RE: NHDB-I010()
I-10 Mobile River Bridge and Bayway
Mobile and Baldwin Counties

Wallace Tunnel Design Exception Request
East Tunnel Interchange Ramp B – Conceptual Design Exception Request
West High Level Approach Alignment – Conceptual Design Exception Request
I-10 Bayway Reduced Inside Shoulder – Memorandum

Subject: Project No. DPI-0030(005)
I-10 Mobile River Bridge and Bayway
Design Exceptions Request

RE: Technical Memorandum
East Tunnel Interchange Ramp B Stopping Sight Distance (SSD)

Figure 1: East Tunnel Interchange Ramp B Plan View

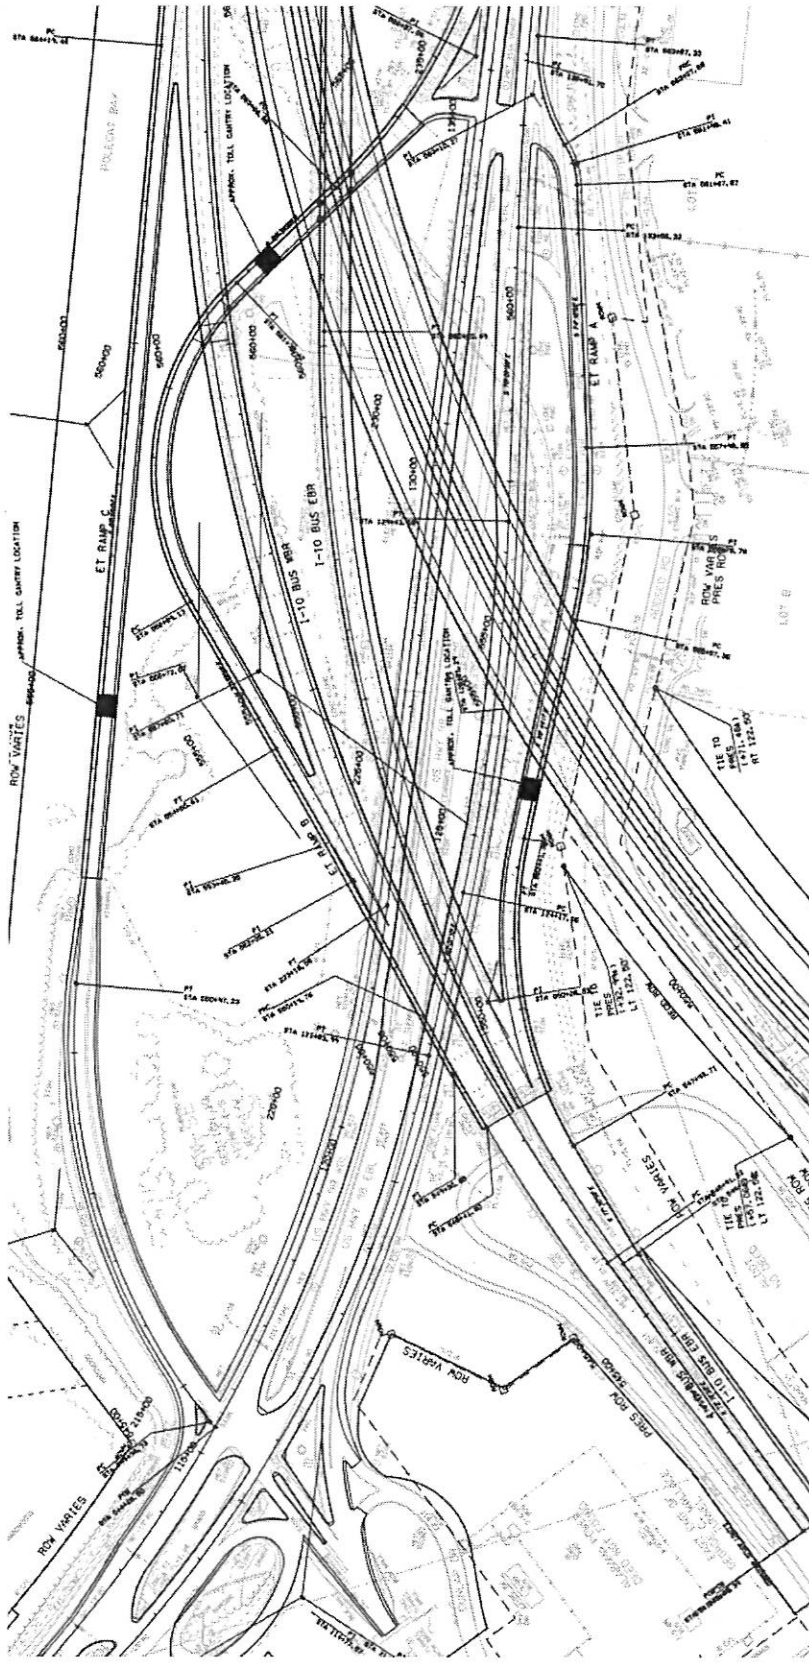
A design exception is requested for Horizontal Stopping Sight Distance (SSD) for Ramp B, PI Station 559+76.72.

Ramp B has a 40 mph design speed. This design speed requires SSD of 305 ft. (K=44) (AASHTO 2011 Green Book, Table 3-34). The proposed PVI at Station 554+97.10 provides a SSD of 272 ft. (K=32). The proposed SSD does not meet the minimum SSD for 40 mph and only provides SSD for 35 mph, see Table 1. The proposed PI at Station 559+76.72 provides a SSD of 180 ft., which does not meet the minimum SSD for 40 mph and only provides SSD for 25 mph, see Table 2

To achieve the required horizontal SSD for 40 mph, the entire horizontal alignment would need to be revised. The curve at PI Station 559+76.72 would need a radius far exceeding what can be provided in this constrained location or the inside shoulder would need to be substantially wider to achieve the SSD.

Mott MacDonald recommend the Ramp B alignment continue with the proposed alignment under a design exception for the stopping sight distance criteria. The exception is to accept 35 mph design speed criteria for vertical SSD in lieu of the 40 mph requirement for this one vertical curve (PVI Station 554+97.10) and a 25 mph design speed for horizontal SSD in lieu of the 40mph requirement for the horizontal curve at PI Station 559+76.72

Figure 2: East Tunnel Interchange Ramp B Profile View

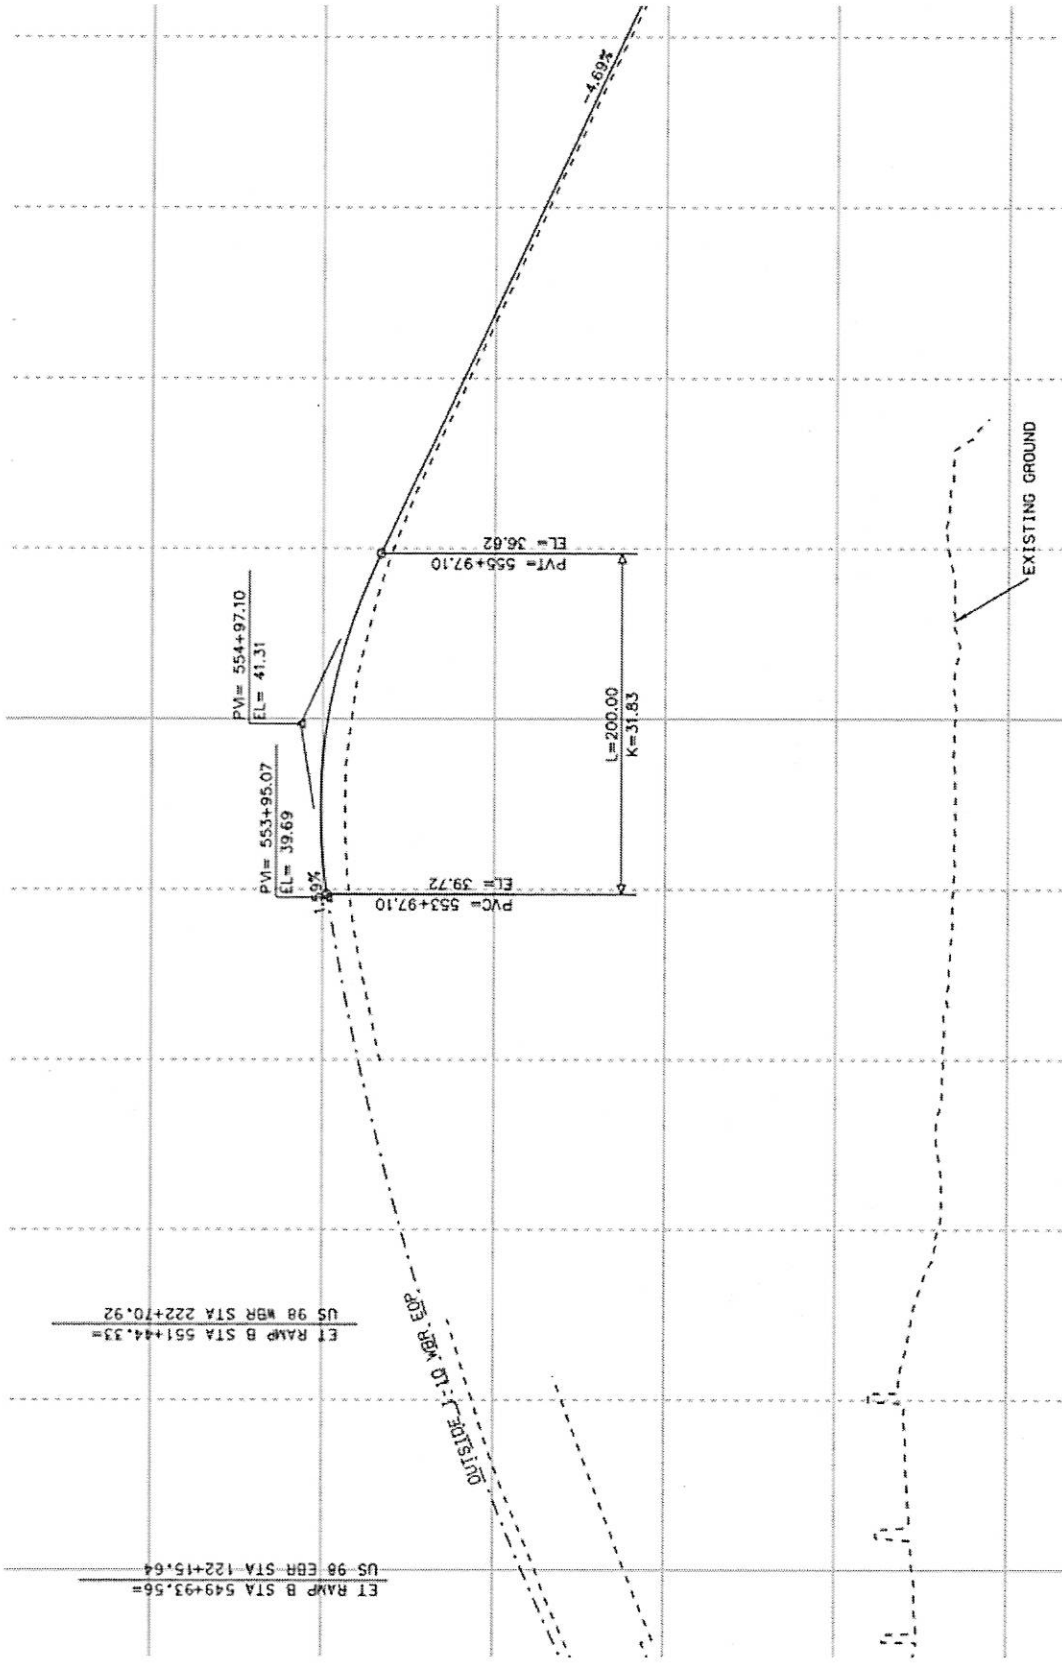
A design exception is requested for Vertical Stopping Sight Distance (SSD) for Ramp B, PVI Station 554+97.10.

To meet the minimum vertical SSD for 40 mph. the Ramp B PVI would require a curve length of 276 ft. (200 ft. provided). The location of this PVI does not allow for the curve to be extended toward the tunnel. I-10 Business going into the tunnel is already in a vertical curve Ramp B ties into I-10 Business in this vertical curve. Any attempt to lengthen the vertical curve at PVI 554+97.10 creates a steeper grade and therefore increases the needed vertical curve length and would move the gore closer to the Wallace Tunnel. Alternatively, we investigated moving the PVI further from the tunnel entrance. This would require steepening the grade on the exit tangent and therefore require a longer vertical curve, due to the constraint of passing under WB I-10 Business.

Figure 1: Horizontal Sight Triangles for 65mph Design Speed Superimposed on Selected Alternative

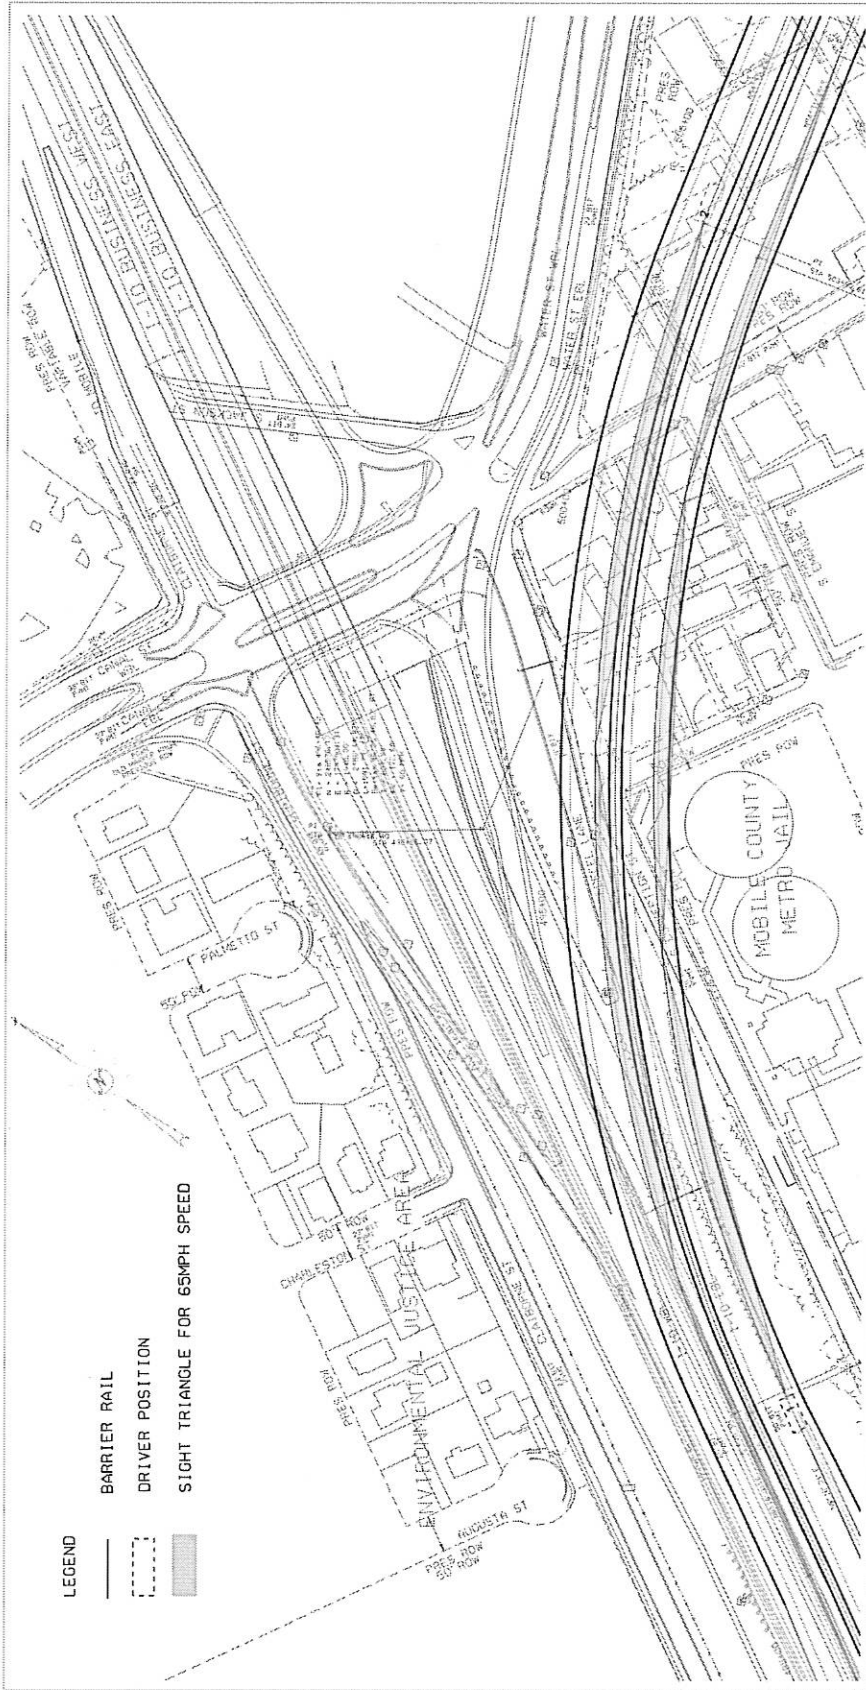
A design exception is requested for Stopping Sight Distance (SSD) for the westbound bridge inside lane and eastbound outside lane of the I-10 West High Level Approach.

I-10 has a design speed of 65 mph. This design speed on a 3.565% vertical grade requires a minimum SSD of 607 ft. upgrade and 691 ft. downgrade (AASHTO 2011 Green Book, Table 3-2). The eastbound upgrade I-10 bridge alignment through the elevated curved section provides a stopping sight distance of 522 ft. The westbound downgrade I-10 bridge alignment provides a stopping sight distance of 534 ft. The available SSDs in both directions do not meet the minimum SSDs for the design speed of 65 mph and only are adequate for a 55 mph design speed (see Table 1). Horizontal sight lines for the pertinent design speed are obstructed by a 36-inch barrier rail located along the 12 ft. shoulders, limiting the ability to achieve the desired sight distances (see Figure 1).

To meet the minimum SSD requirements for the 65mph design speed, the eastbound bridge alignment will require widening of the outside shoulder from 12ft. to 18.3ft. through the curved segment. The westbound bridge will require widening the left shoulder from 12 ft. to 24.1 ft. These shoulder widths exceed AASHTO's recommended limiting width of 12 ft. The concern of the shoulders being used as passing lanes and or likely as "observation deck" particularly on the eastbound bridge section becomes more evident with these wide shoulders. More so, right of way restrictions towards the Mobile County Jail and the narrow air space between the bridges leave little room for widening of the outside shoulder of the eastbound bridge and the inside shoulder of the westbound bridge, respectively.

The Thompson team recommends both the eastbound and the westbound bridges to continue with the proposed alignment under a design exception for the stopping sight distance criteria, allowing for an inside shoulder dimension of 12 ft. westbound and 12 ft. outside shoulder eastbound. The exception is to accept 55 mph design speed criteria for SSD in lieu of the 65 mph requirement in this 1600 ft. length horizontal curve on the west HLA coming off the Main Span.
